In the Drawings:

REMARKS

TIRE WHEEL...

Atsushi Tanno - 4386.77652
Greer, Burns & Crain, Ltd. (Patrick G. Burns)
Annotated Marked-Up Sheet 1 of 1 (312) 360-0080

Fig.3

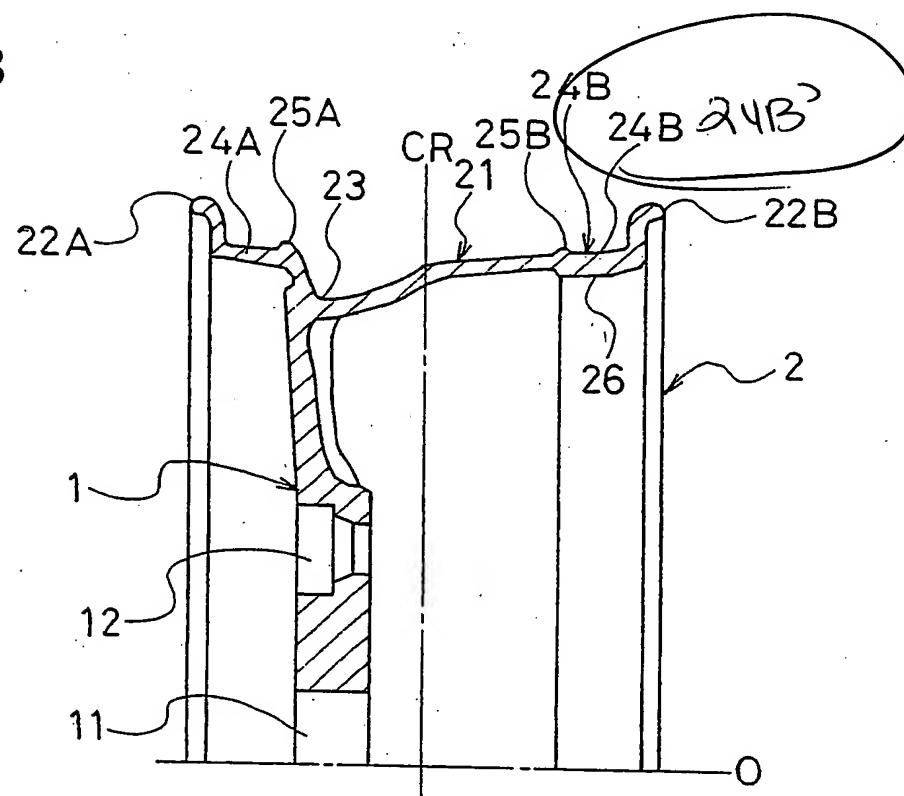
The attached sheet of drawing includes a change to FIG. 3. An Annotated Sheet showing the change is attached along with the Replacement Sheet.
